STAFF REPORT
(ONE-STEP FINAL PLAT)

CASE NUMBER: SUB 2002-121 -- LINWOOD SCHOOL ADDITION

LOCATION: Southeast corner of Harry and Hydraulic

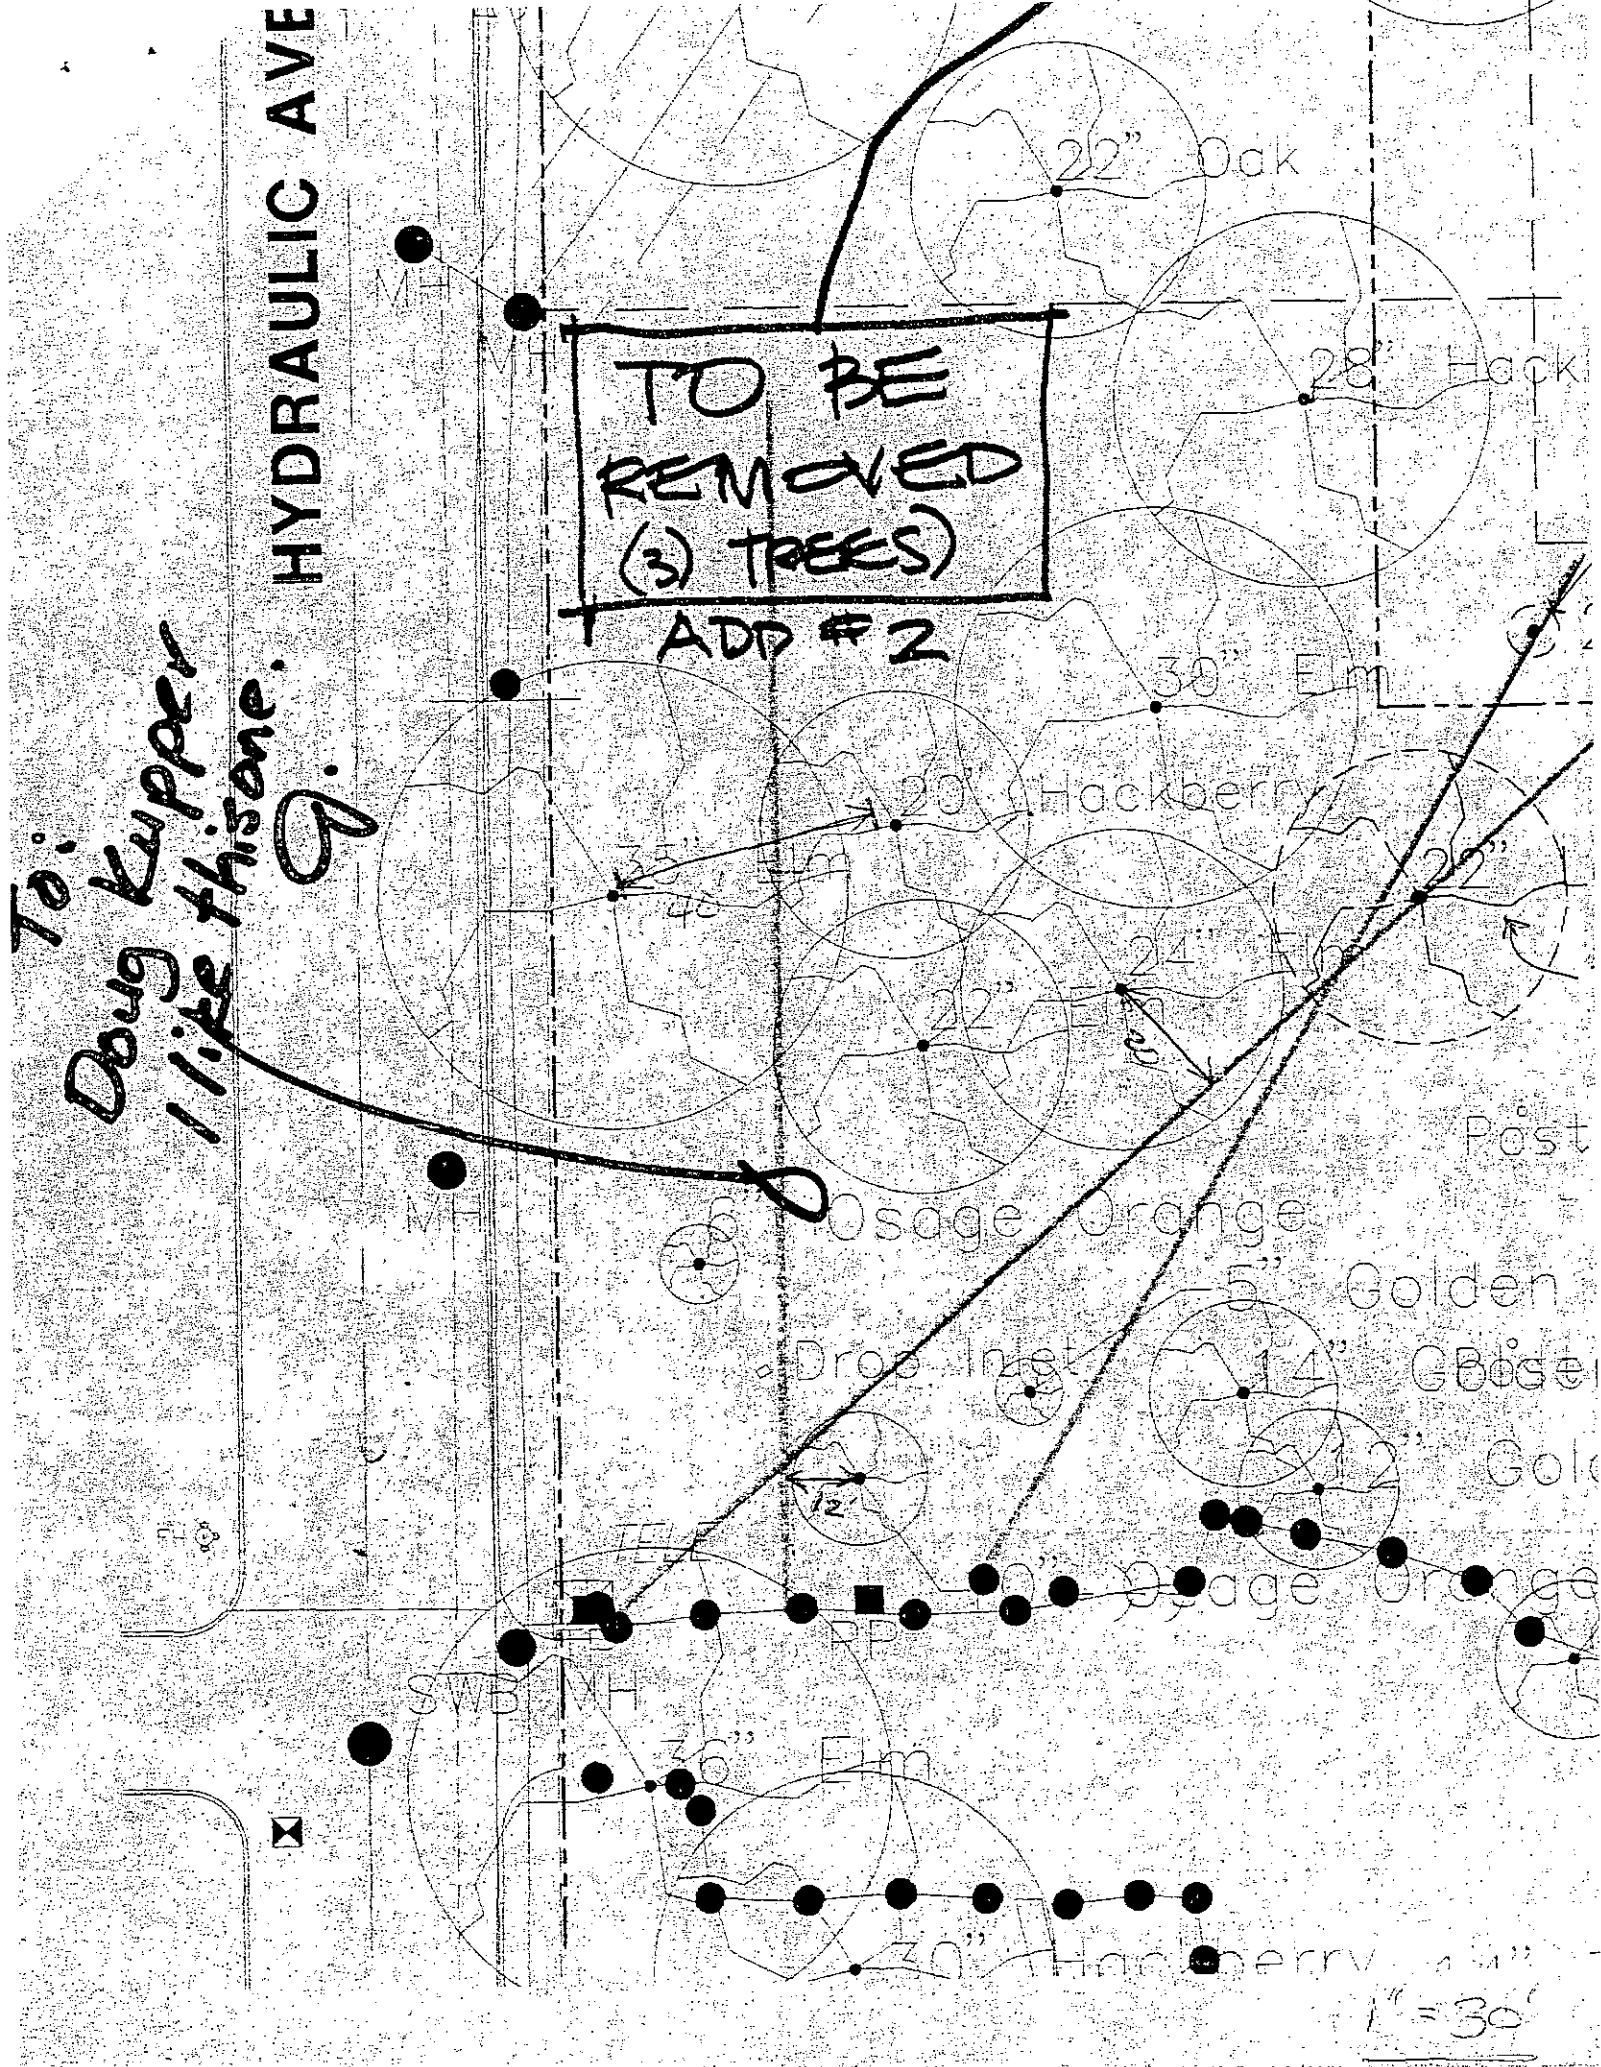
To:
Doug Kupper
1 like this one.

TO BE
REMOVED
(3 TREES)
